Document Number:	N14134
Date:	2009-11-18
Replaces:	
Document Type:	National Body Contribution
Document Title:	NB of Japan's contribution on harmonization between the NFC
	standards and ISO/IEC 14443
Document Source:	National Body of Japan
Project Number:	
Document Status:	For consideration at the SC6 Study Group meeting in Berlin.
Action ID:	FYI
Due Date:	
No. of Pages:	18

14443/NFC Harmonization

Contributions to standardise requirements for interoperability of applications that are to be executed between 14443 (PICC and PCD) and 21481 compliant devices

Figure 2.1 — Anticollision (14443-3) and SDD (18092 Passive Mode) flow

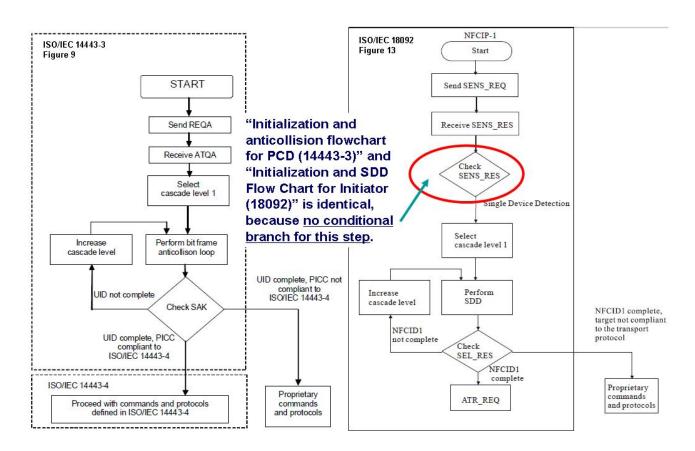
There is no essential difference between the type-A of 14443-3 anticollision flow and the 106 kb/s Passive Communication Mode of 18092 Single Device Detection flow. Mnemonics are different but meanings are the same. The figure 9 of ISO/IEC 14443-3 and the figure 13 of ISO/IEC 18092 are identical except the step of "Check SENS_RES".

The "Check SENS_RES" means an intentional clarification for checking SENS_RES (ATQA) there is no conditional branch at this check point.

For these reason, we can say that the figure 9 of ISO/IEC 14443-3 and the figure 13 of ISO/IEC 18092 are identical, therefore figure 13 of 18092 can refer figure 9 of 14443-3.

Figure 2.3 — Activation protocol in Passive communication mode (ISO/IEC 18092 Figure 24)

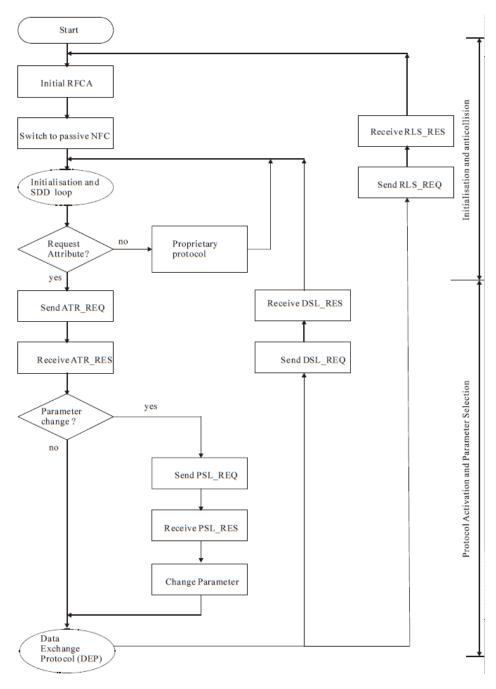
Figure 2.2 is the figure 24 (the title is "Activation protocol in Passive communication mode") of the ISO/IEC 18092. The ISO/IEC 18092 clause 12.2 clearly specifies the general flow and how it branches to the proprietary protocol box. The "Transmission protocol" and "Organization, security and commands for interchange" of JIS X 6319-4 may be activated in the proprietary protocol box. This mechanism and technology are used in Japan.

From the technical point of view, it is possible to let ISO/IEC 18092 refer JIS X 6319-4 as the Passive Communication Mode 212, 424 kb/s. (424 kb/s have added to the revised version of JIS X 6319-4.)

Figure 3.3.1 - General flow of the ISO/IEC 18092 NFC-mode of Active-mode

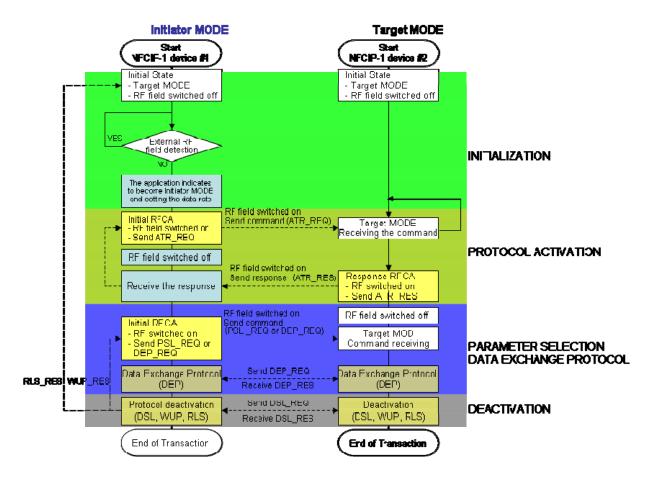
The default condition of the NFC-mode (ISO/IEC 18092; NFCIP-1) is Passive-mode of Target-mode. The NFCIP-1 device may switch to Initiator mode only if required by the application. Either Passive-mode or Active-mode in NFC-mode is decided while the Protocol Activation and Parameter Selection sequence. If the Initiator switches off its RF field after sending ATR_REQ, the device operates in Active-mode, the Target device will behave according to the ISO/IEC 18092 Active Communication Mode. See figure 3.1.1.

If two 21481 devices are already in Active-mode, it is possible to switch to Passive-mode only by terminating the current transaction and fall back to start of the activation sequence. The communication between Active-mode device and Passive-mode device does not work. Therefore, the chance ratio is 4,8 % not 9,5 %.

Figure 3.29 - PICC-mode added to 21481

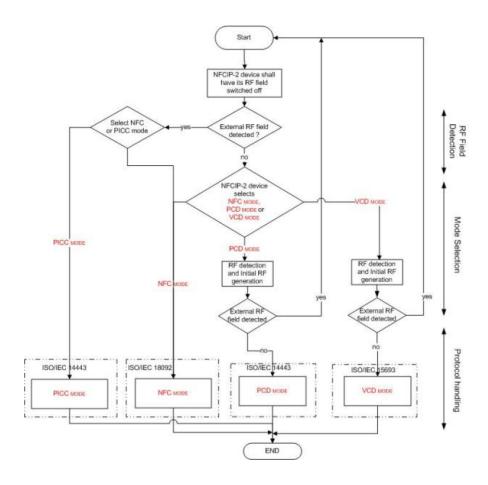
Combinations of the modes supported by 21481 can lead to scenarios where two NFCIP-2 devices in different modes - device 1 in mode X and device 2 in mode Y - are neither able to detect each other nor to communicate.

Once a 21481 device gets into the PICC mode, it can never switch into the PCD mode or NFC mode or VCD mode.

Once it gets into the NFC mode, it cannot detect Type B (14443 of 106 kb/s). There are two modes in the NFC-mode. Those are Initiator-mode and Target-mode where as the default mode is Target-mode. NFCIP-1 does not execute technology polling alternation.

Once the 21481 device gets into the PCD mode, it cannot detect NFCIP-1's Passive mode of 212 kb/s and 424 kb/s.
